Town of Essex, Vermont
Application for Zoning Permit
www.essex.org

TOWN OF ESSEX, VERMONT
APPLICATION FOR CURB CUT / UTILITY PERMIT

Re: Rotunda Auto Body, Gauthier Road, Essex Junction, Vermont

**STORMWATER MANAGEMENT PLAN
JOE & KIM ROTUNDA AUTO BODY SHOP
Gauthier Drive, Essex, Vermont**

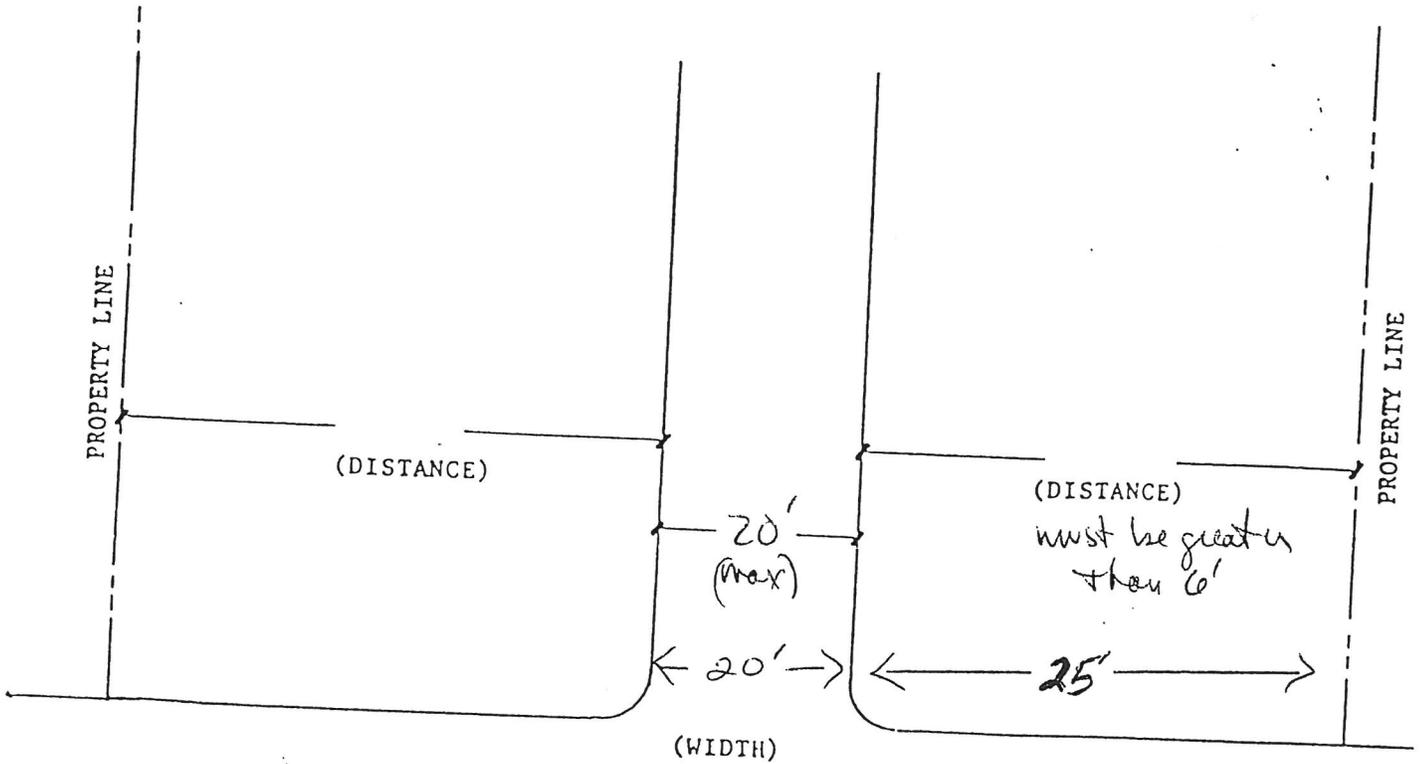
Comments and / or special instructions from Director of Public Works / Town Engineer:

1. width of commercial drive to be 20'
2. no portion of driveway to be within 6' of neighbors property.
3. driveway to be paved within limits of road right of way
4. any damage to sidewalk to be fixed by applicant
